**COUNTY OF MIDDLESEX - INTERROGATORY #1**

Filed: May 23, 2013  
EB-2013-0040 and EB-2013-0041  
Exhibit B  
Tab 1  
Schedule 3  
Responses to County of  
Middlesex Interrogatories  
Appendix A

AREA	SUBJECT
1001 115kV TRANSMISSION LINE	STEEL POLE DESIGN PLAN & PROFILE DRAWINGS SHEET 1 OF 12
CLIENT DWG. NO.	REV.
DRAWING NO. 1235-2-P012-S1	G

**APPENDIX 'A'**

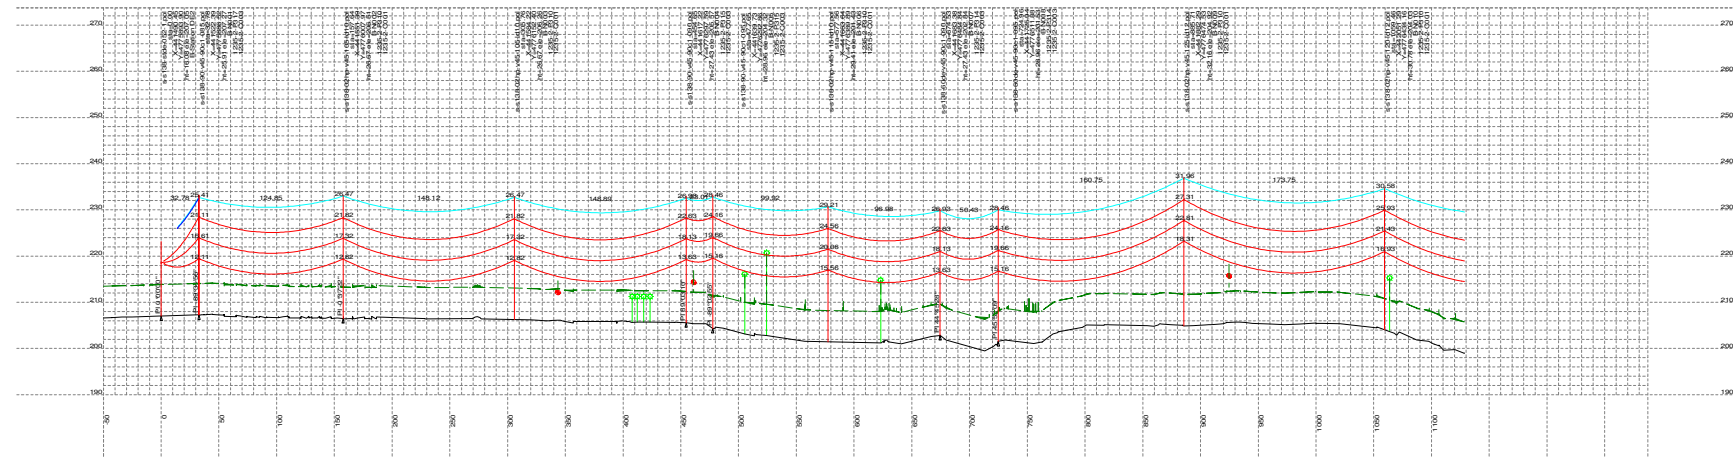
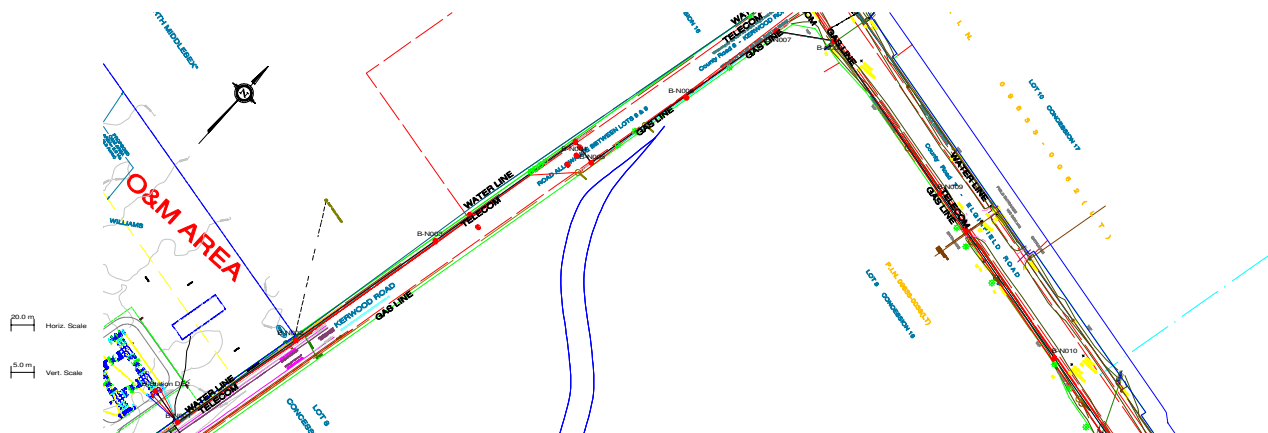
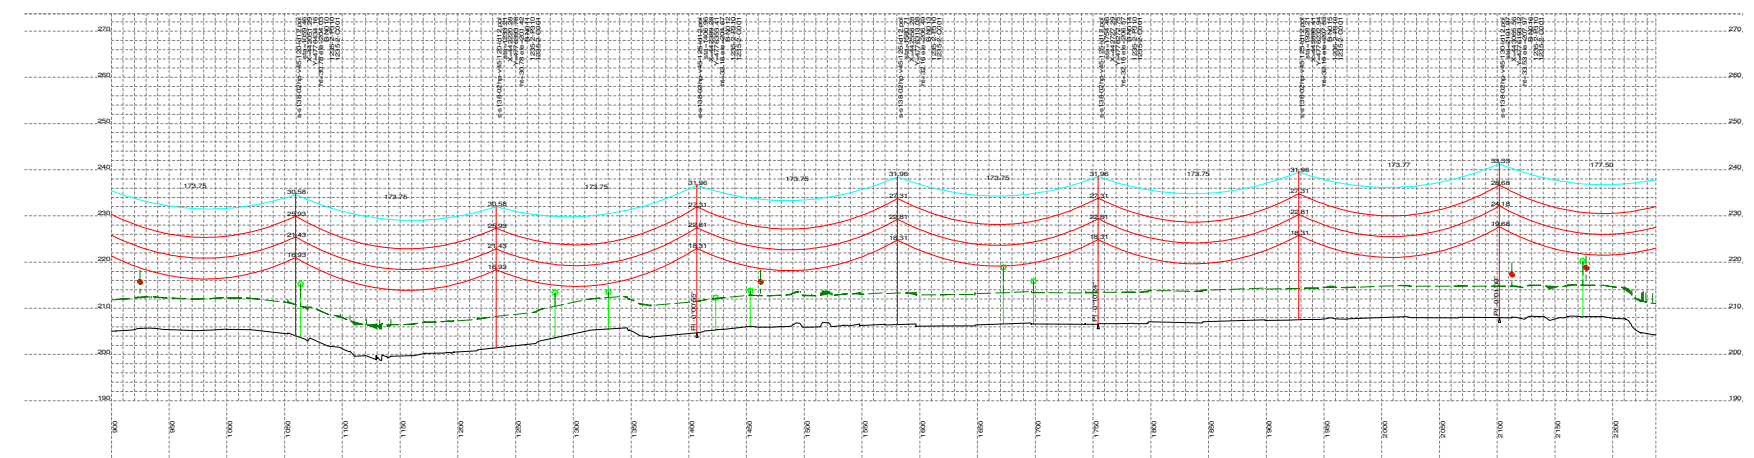
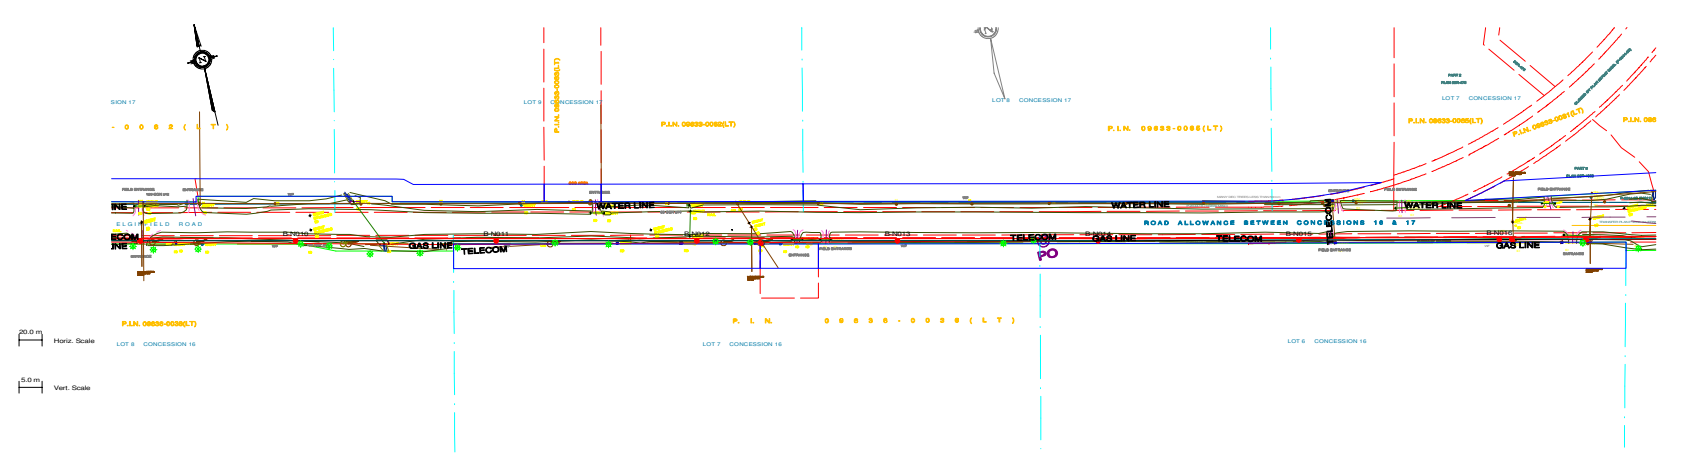
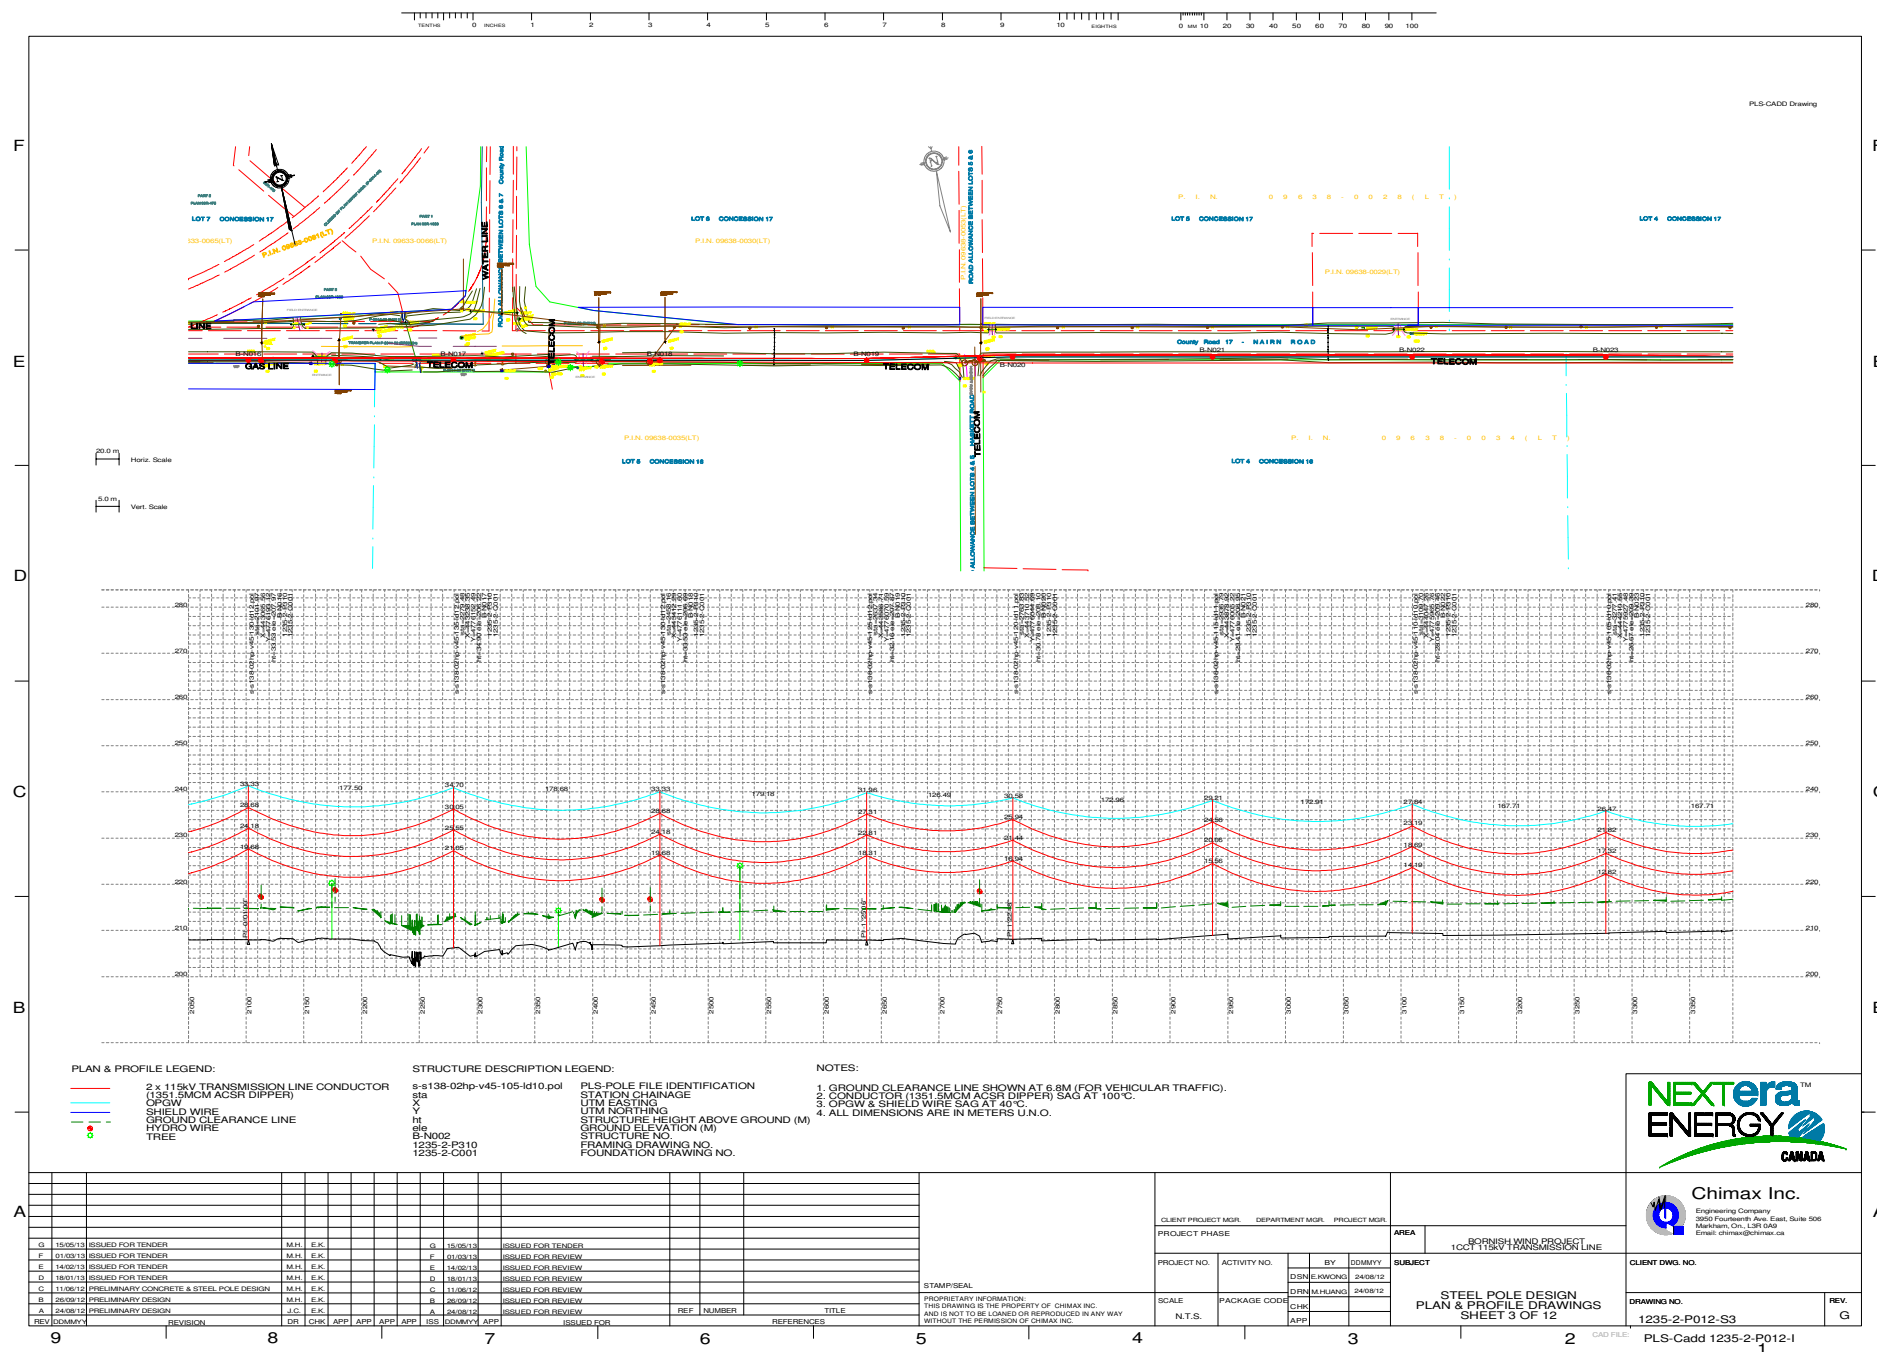
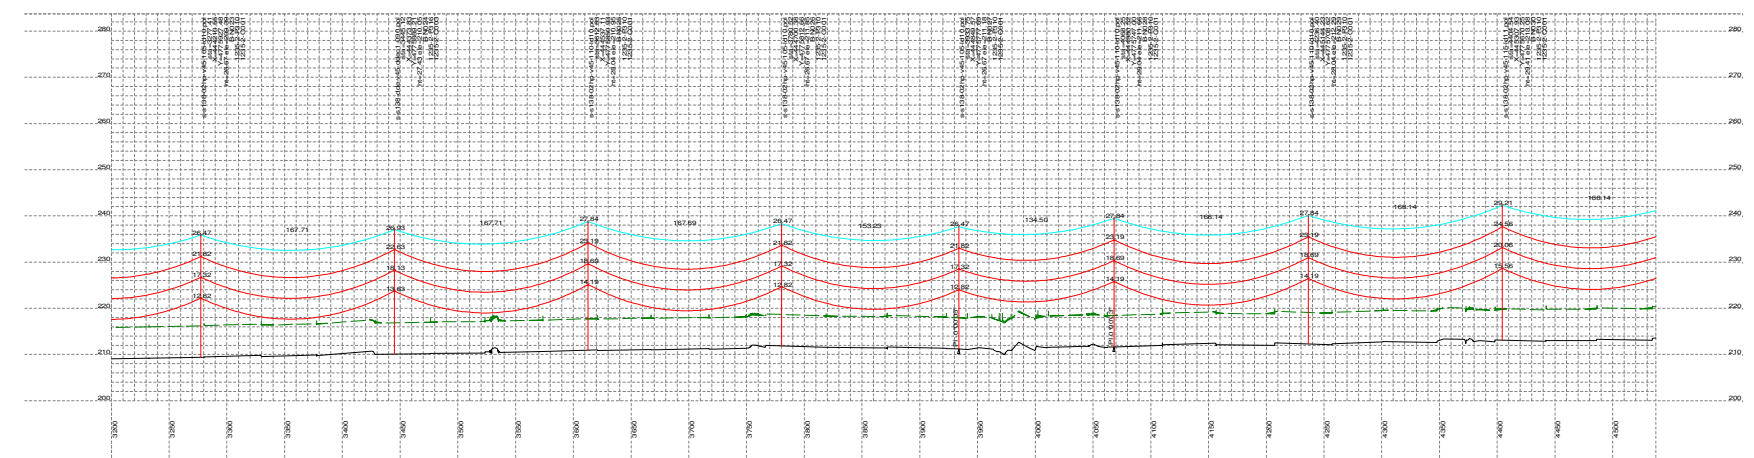
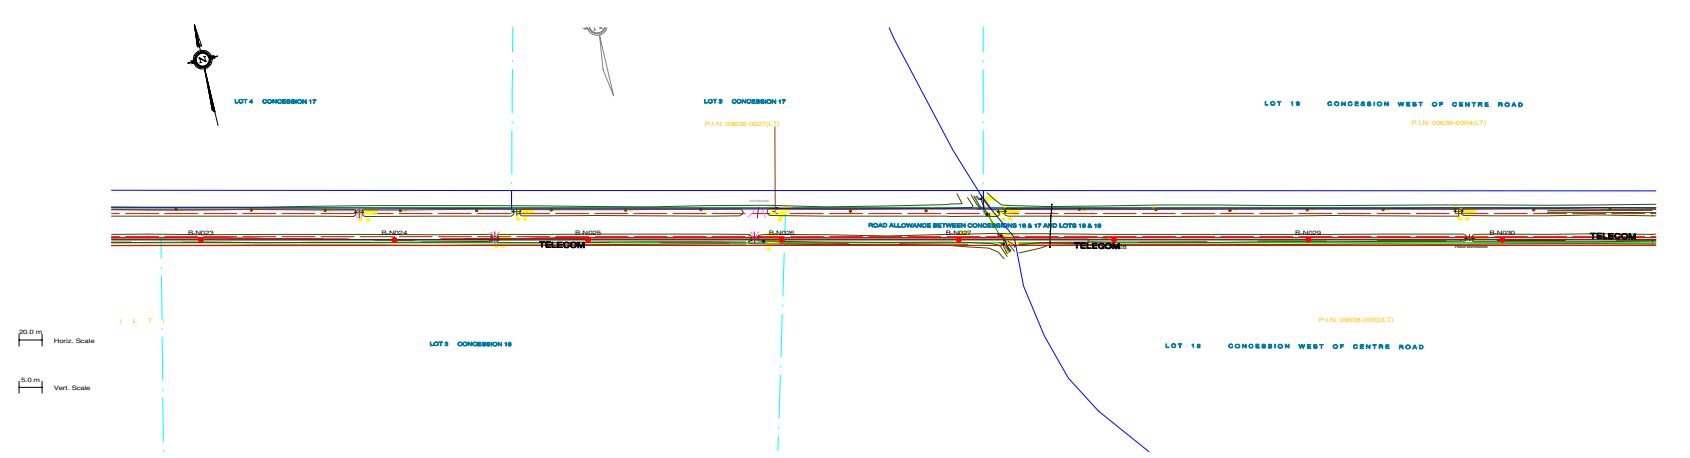
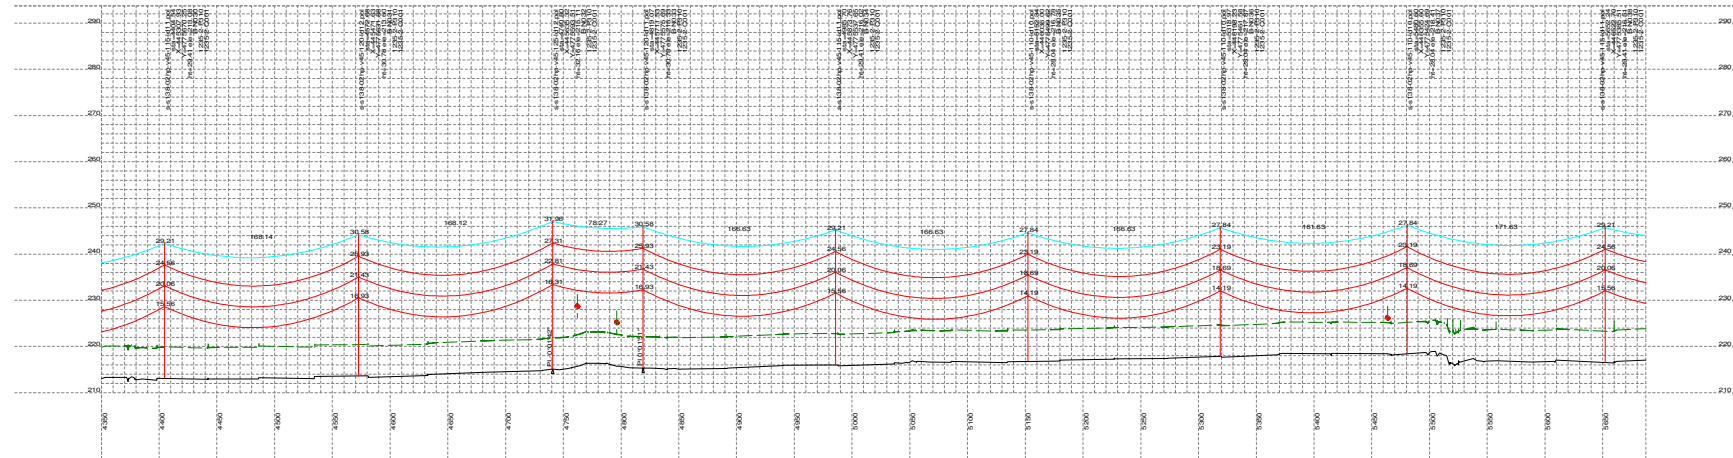
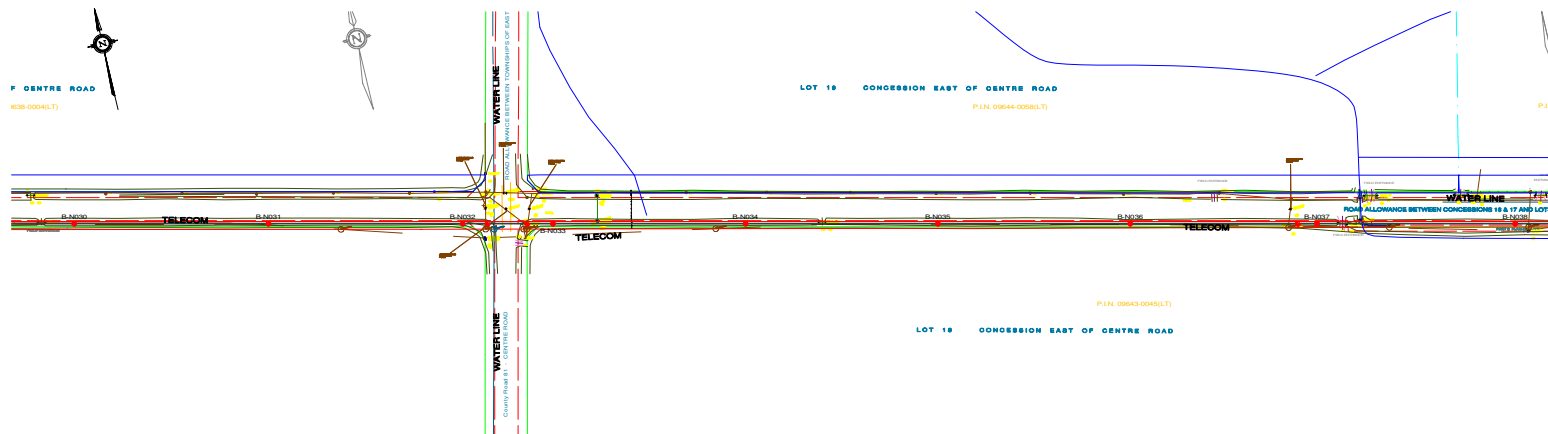
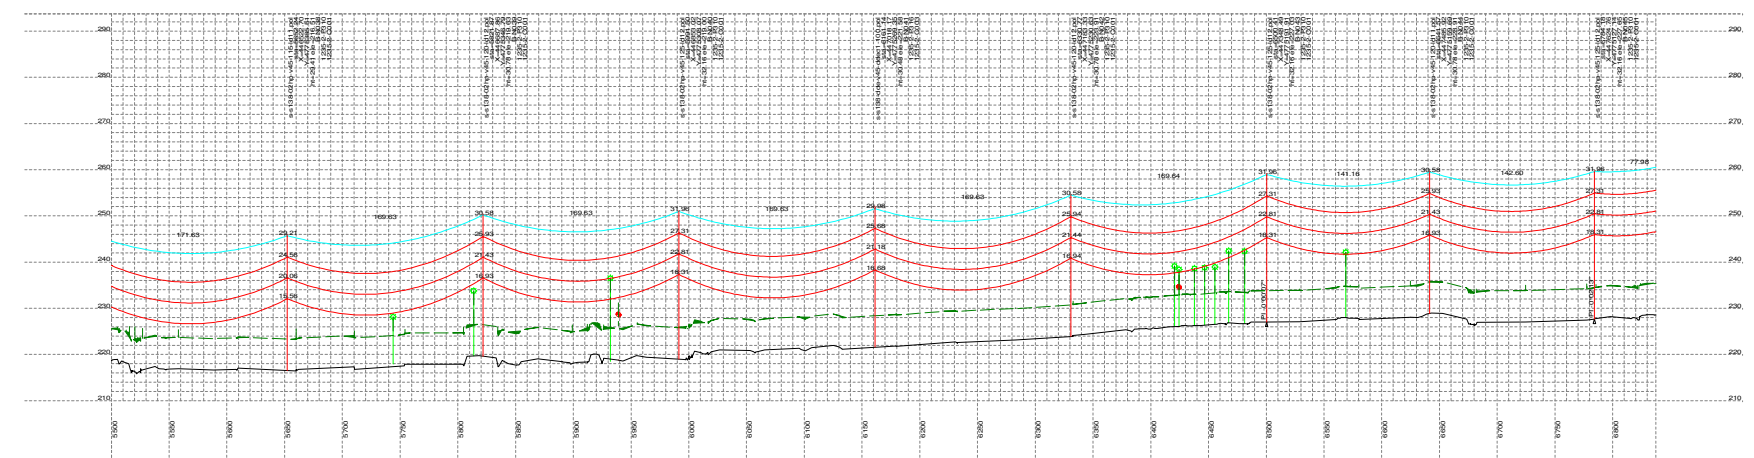
Please provide detailed engineering drawings showing the exact location of all poles and other appurtenances proposed to be located within County road allowances for transmission lines, including all material and construction specifications of poles, wires, guying, foundations, trenching, temporary conditions, and any other items related to this infrastructure.

Please see profile drawings in **Appendix 'A'** in respect of EB-2013-0040 and **Appendix 'B'** in respect of EB-2013-0041 depicting the current design, which is subject to final engineering. Earlier versions of these sets of drawings were provided to the County's Engineer on November 12, 2012. These drawings show the proposed pole, wire and anchor locations. Plans with respect to foundations, materials and construction specifications are not yet finalized. The physical design specifications for the proposed transmission line, including with respect to potential materials, are described in Exhibit D, Tab 1, Schedule 1. In addition, illustrations of potential pole structures and framing designs are provided in Figure 4 of Exhibit B, Tab 2, Schedule 5.
